STATE OF FLORIDA  
DEPARTMENT OF ENVIRONMENTAL REGULATION

IN RE: )  
 )  
Florida Power & Light Company )  
St. Lucie Power Plant Unit No. 2: )  
Modification of Terms and Condi- )  
tions of Certification No. )  
PA-74-02, St. Lucie County, )  
Florida, )  
 )  
Petitioner. )  
 )

PETITION FOR MODIFICATION  
OF CONDITIONS OF CERTIFICATION

UNIT 2 OCEAN DISCHARGE STRUCTURE  
(Original Alternating Diffuser  
Design)

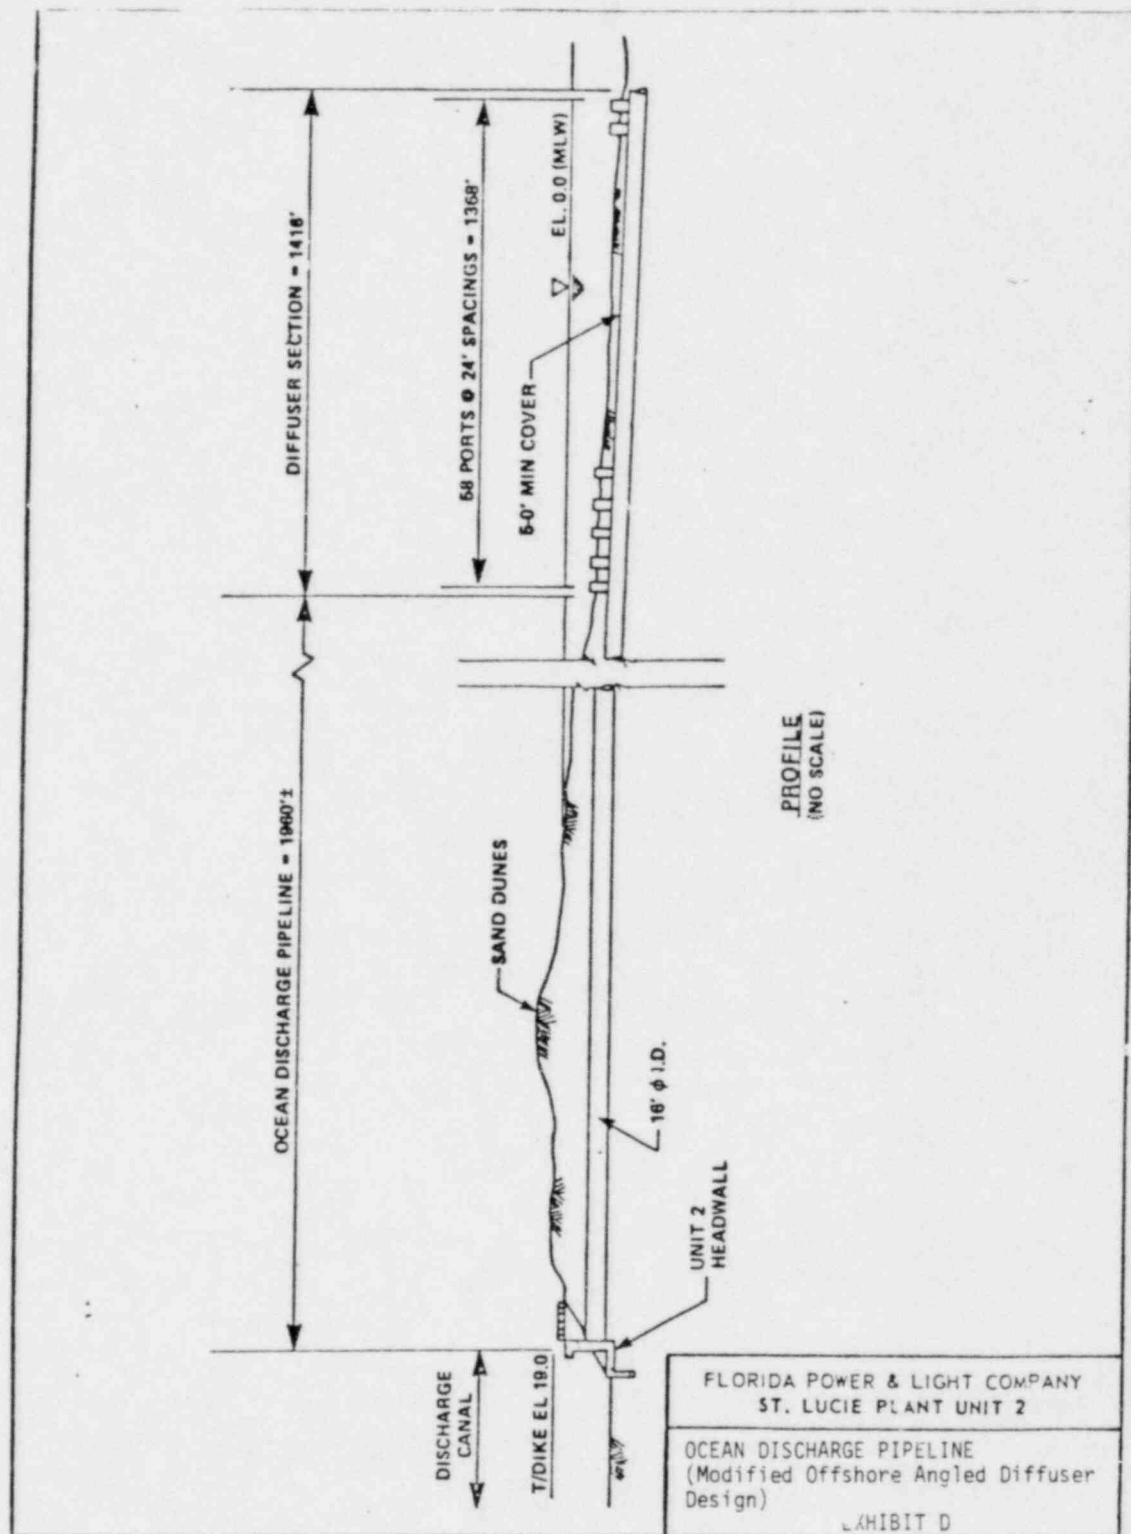
15. The modified offshore angled diffuser, approved by the Board by order dated April 7, 1980, consists of a 16-foot diameter (inside diameter) buried concrete conduit that extends into the Atlantic Ocean approximately 3,050 to 3,070 feet from the shoreline. The last 1,380 to 1,400 feet of the pipe is mounted with 58 four-foot diameter riser pipes spaced 24 feet between centers that extend above the ocean bottom and have 16-inch ports oriented to discharge at a 25° angle from the centerline of the diffuser, directed offshore. (See Exhibits D and E.)

Volume contained  
within 17°F isotherm  
envelope of diffuser

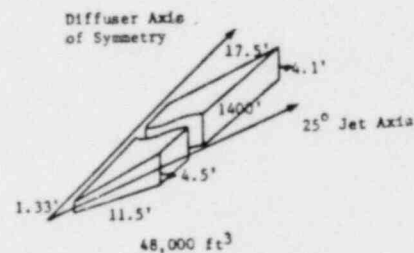
13. Petitioner proposes that the description of the measurement method for determination of compliance with the 12-foot mixing zone (see Section II.A.2 of the Conditions) be modified to reflect the originally contemplated measurement direction while also accommodating the modified design of the multiport (offshore angled) diffuser approved by the Board by order dated April 7, 1980. The proposed modification is needed because a literal reading of the current 12-foot mixing zone limitation would artificially restrict the zone of influence of the heated discharge water to a smaller volume than that contemplated in the initial site certification.

18. For the reasons stated above, Petitioner proposes that Section II.A.2 of the St. Lucie Unit No. 2 Special Conditions of Certification be modified as follows:

Figure 3. Location of benthic sampling stations.

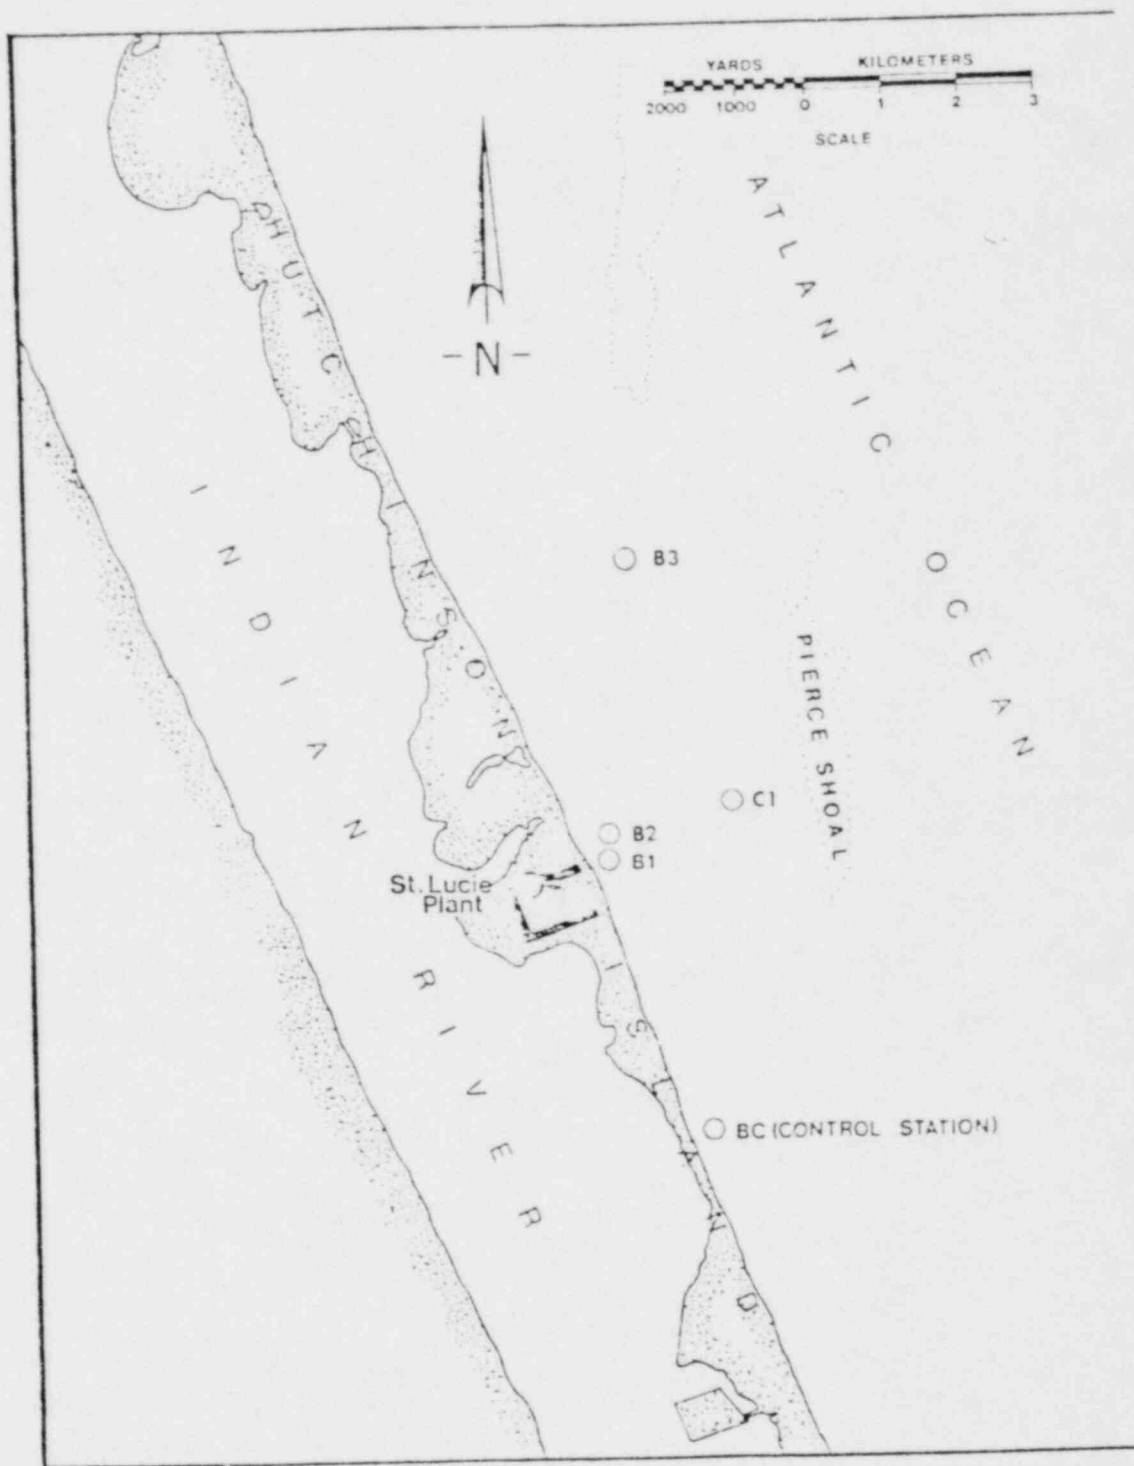
plume's warmest spot (Figure 3). Four or more replicates will be taken. Station 2 of the current program will be retained as Station C1 to help integrate the modified program with the existing data. Station 5 of the current program will be retained as Station B3 for at least one or two years after Unit 2 goes on-line, to document the probability that there is no effect of combined Units 1 and 2 discharge at this location. Benthic sampling at other offshore stations (3 and 4) will be terminated.

Figure 4. Location of gill net stations.

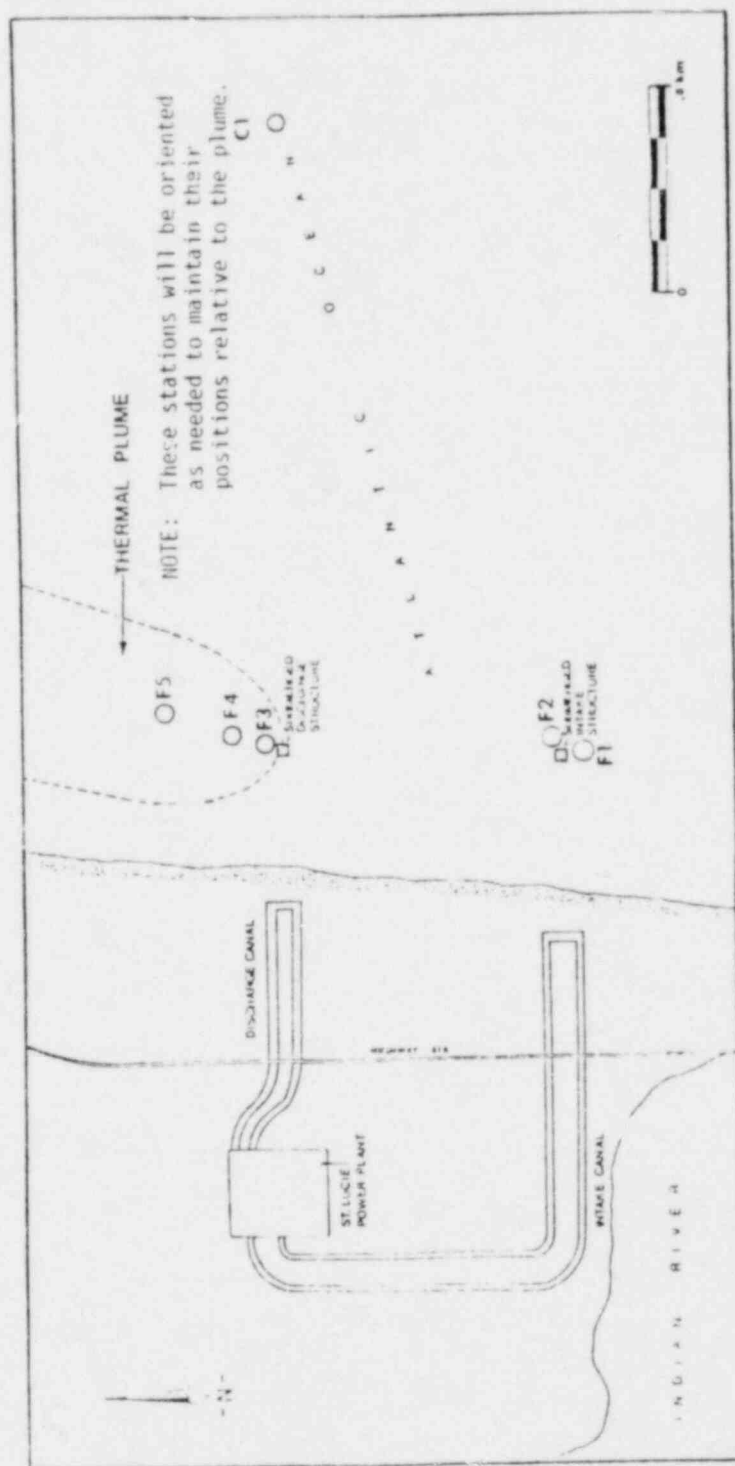
The sampling program will consist of nearshore gill netting. Two sampling stations will be established near the intake structure and three in the discharge area (Figure 4). The discharge station samples will provide data on near, intermediate and distant effects of the plume on fish distribution. Stations will be located in the thermal plume's warmest spot and approximately 200 meters and 450 meters from this warmest spot. These stations will be sampled as follows: once per month during April through September when the commercially important migratory species are generally not present offshore the St. Lucie Plant and twice per month during October through March when these species are present. Station 2 (C1) will be retained to help integrate the data from the modified program with the existing data.
